## **Packet Guide**

BAR 21-07-01

854 Locust Avenue, Tax Parcel 510092000

Project: Garage construction

**NOTE:**  
EXISTING HARD COAT STUCCO TO REMAIN. REPAIR AS REQUIRED TO ADEQUATELY INSTALL NEW EIFS SYSTEM PER MANUFACTURERS WRITTEN INSTRUCTIONS.  
EXISTING WALL CONSTRUCTION / STOREFRONT / DOORS TO REMAIN UNDISTURBED - TYP.

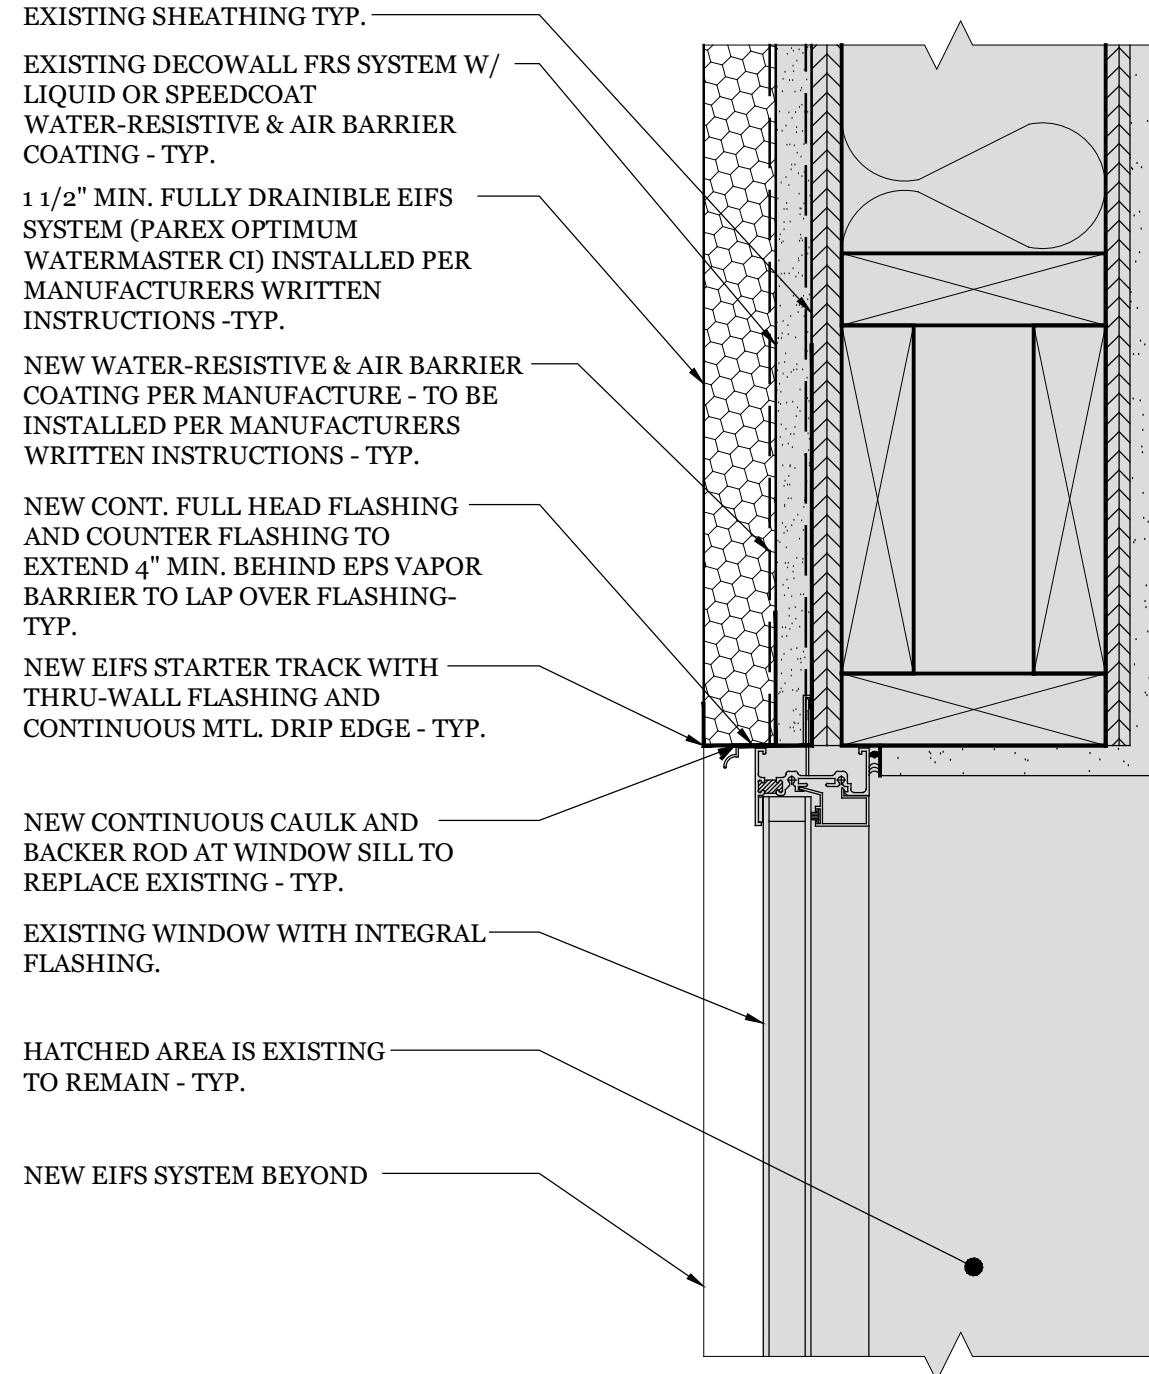
The proposed repairs will apply a Parex EIFS system over the existing hard coat stucco. The primary details are shown on sheet A-455, which references to the existing hard coat stucco system (Decoplast Decowall FRS) and details how the Parex EIFS system will be installed (the water resistive and air barrier coating installed over the existing stucco). A-455 also illustrates the details at the various components—door and window trim and sills, roof parapet, etc.

Aside from the material and methods proposed for the repairs, the repairs will result in a slight reveal at the perimeter of the existing windows, doors, and vents. As built, the stucco is flush with these components—see the images below. This modification is detailed on Sheet A-455. This new detail will be consistent on the building—and, in fact, be similar to the reveal condition at the brick wall segments. Staff suggests this is an acceptable detail modification.
